RE: **PUBLIC** Comments of the Minnesota Department of Commerce
Docket No. E002/M-25-142

In the Matter of Xcel Energy's 2025 Integrated Distribution Plan.

Xcel Energy's (Xcel or the Company) Integrated Distribution Plan (IDP) was filed on October 31, 2025. Xcel's Transportation Electrification Plan was filed concurrently.

The Department recommends the Commission accept Xcel's IDP with additional requirements and is available to answer any questions the Minnesota Public Utilities Commission may have.

Figure 26: Xcel Line Utilization by Planning Division (Avg Energy Use / Rated Capacity)

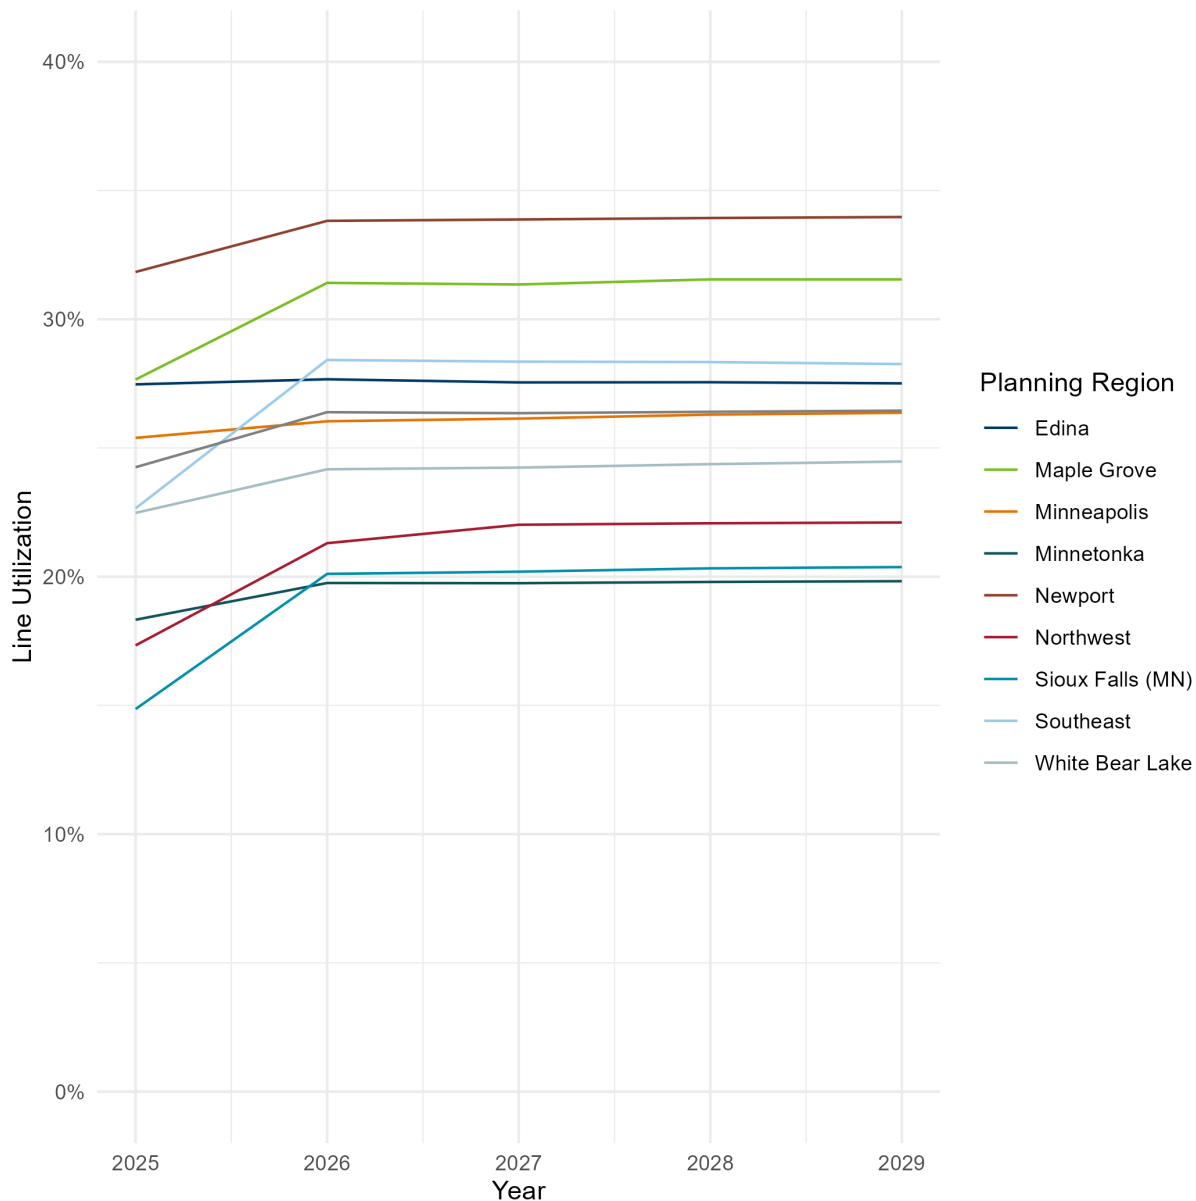
[TRADE SECRET DATA HAS BEEN EXCISED] Generally, most feeders in Xcel's territory have ample capacity for switching, as demonstrated by Xcel's line utilization data from IR 13 shown in Figure 26.⁹¹

The probability of rare N-1 peak day outages and their consequences must be weighed against Xcel's planned budget to mitigate these risks. Xcel plans to spend \$293 million to mitigate N-1 risks listed in Attachment E,⁹² which represents less than half of Xcel's 5-year capacity budget.⁹³ With an estimated annual N-1 risk capacity budget of \$141 million,⁹⁴ it is important to evaluate whether these costs are

Figure 29: Relationship between Overhead Line Miles and Customer Minutes Out for Feeders in Xcel's Service Territory.

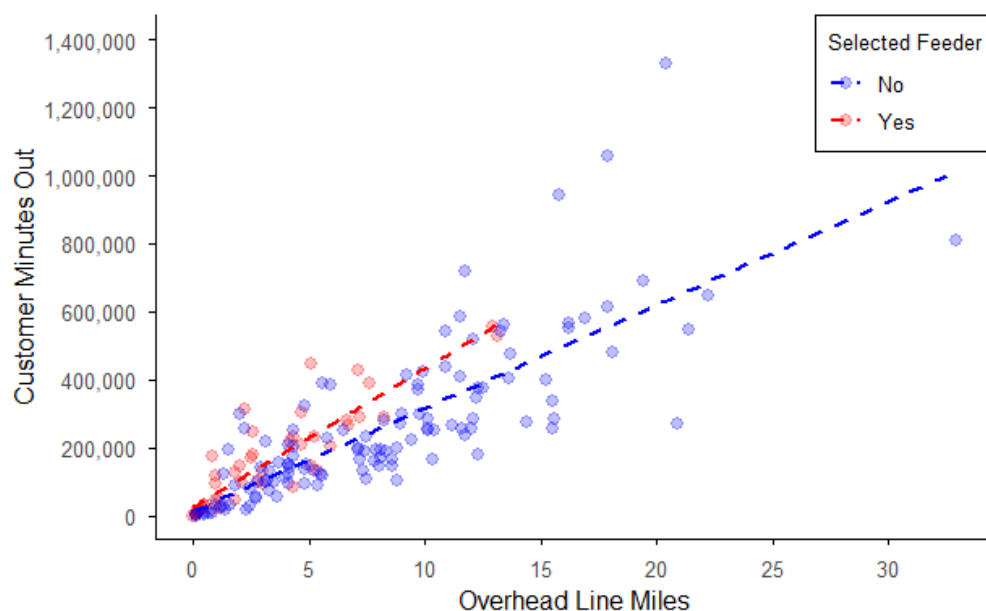
Figure 29 offers empirical support for the Targeted Undergrounding Plan through the demonstration of a clear correlation between overhead line miles and customer minutes out. The linear relationship confirms that feeders with extensive overhead infrastructure experience more significant service

interruptions, which provides justification for the strategic relocation of high-risk segments to improve system resilience and reduce total outage durations. More importantly, the higher rate of accumulation for feeders selected for undergrounding (Selected Feeders 'Yes'), represented by a steeper slope, demonstrates that the First Targeting Method Scenario prioritized feeders with the highest outage impact relative to the overhead line miles. By targeting these higher-value feeders, the method focuses resources on the specific assets where the reliability gains per undergrounded mile are most significant. While the linear relationship provides a high-level physical justification, it fails to account for the diminishing returns of undergrounding in areas where outages are driven by equipment failure or lightning rather than trees and wind.

Figure 34: Xcel Spending by Budget Category and Planning Division

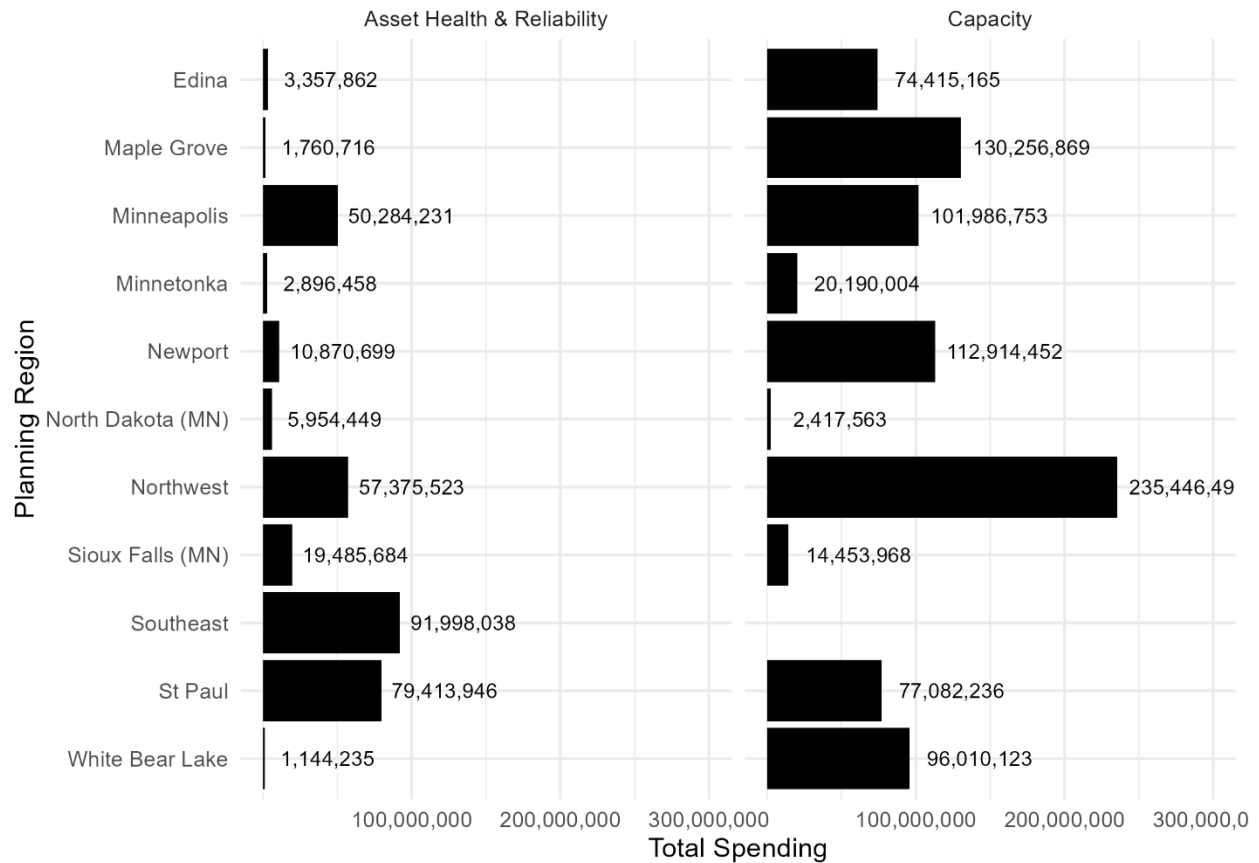
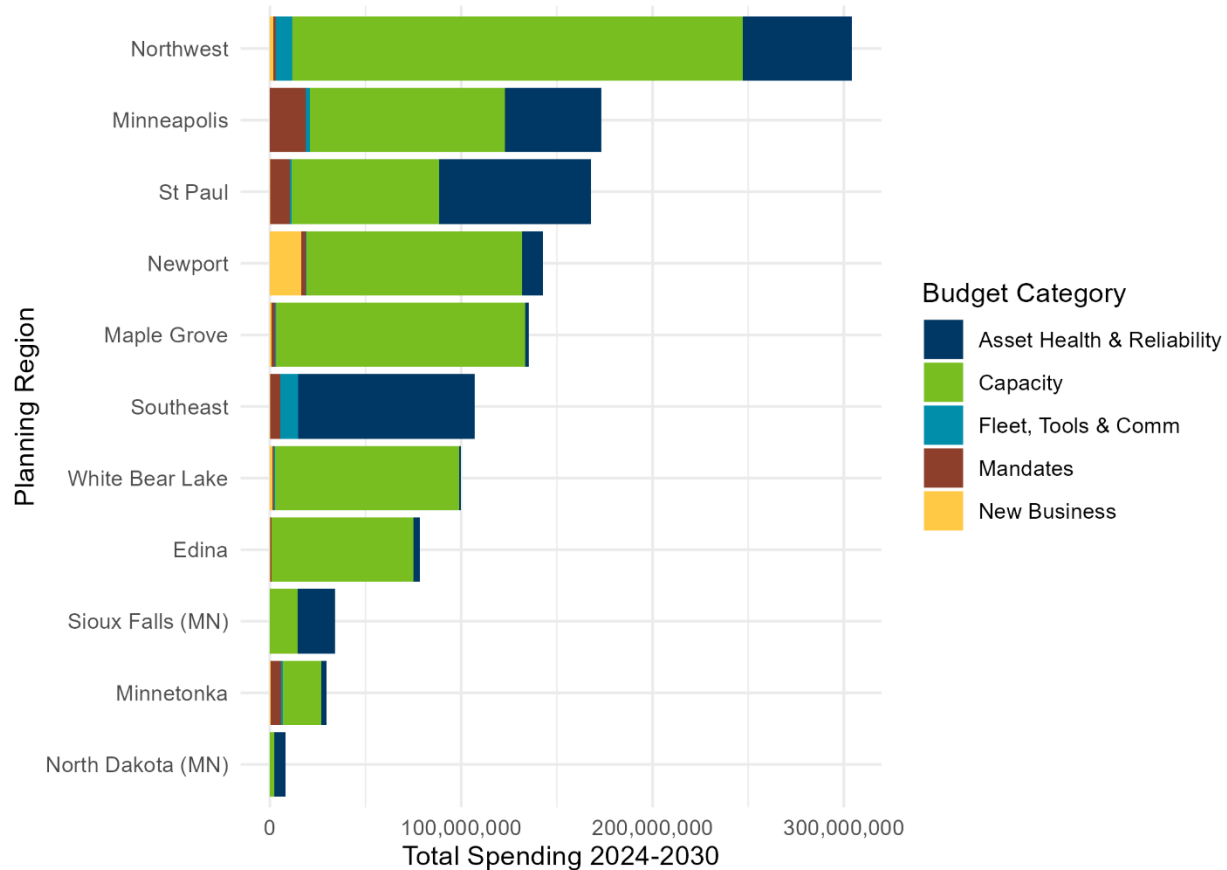
In response to IR 6, Xcel provides a disaggregated breakdown of forecasted distribution spending by budget category and Planning Division for the period 2024–2030. Figure 33 breaks down the top two budget categories by planning division (PD), while Figure 34 presents total spending by PD, broken down by budget category.

The variation in forecasted distribution spending across PD shown above—particularly the differing balance between asset health-driven investments and capacity-driven investments—cannot be explained by population growth alone.
